Rezoning Transportation Analysis

Petition Number: #2022-037

From: Jake Carpenter, PE

Revision Log:

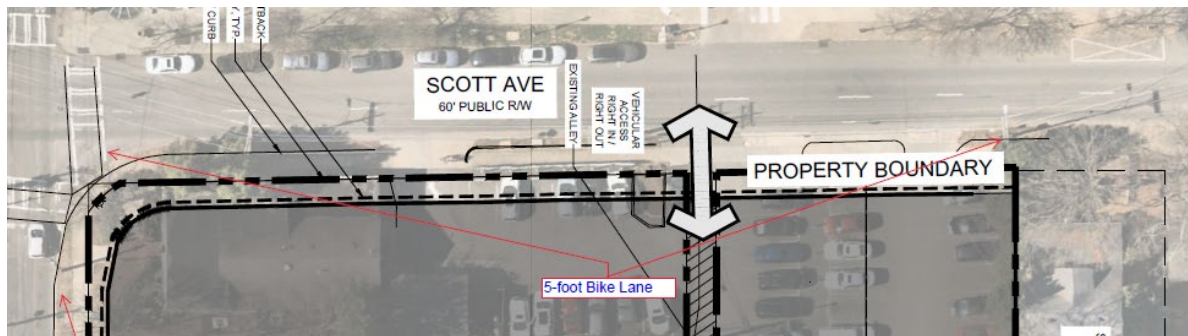
4. Revise site plan and conditional note(s) to commit to construct an 8-foot amenity zone, and an 8-foot sidewalk along the site's frontages of Scott Avenue and East Boulevard. The site plan shall label and dimension both items from the back of curb and gutter.
5. Revise site plan and conditional note(s) to commit to widen East Boulevard, from Fountain View to Scott Boulevard, and provide a 5-foot bike lane that extends from the existing bike lane at Fountain View.

6. **Outstanding Comment from 08-23-2022:** Revise site plan and conditional note(s) to commit to widen Scott Avenue and provide a 5-foot bike lane across the site's frontage. **Note added (8/23/22)** The petitioner has requested to restripe the existing travel-way to match the Scott Avenue typical section south of East Blvd (5-ft bike lane without a buffer) if the existing travel-way can geometrically accommodate the existing on-street parking, 2-thru lanes and a 5' bike lane. Comment to remain until addressed or until CDOT evaluates and approves request.
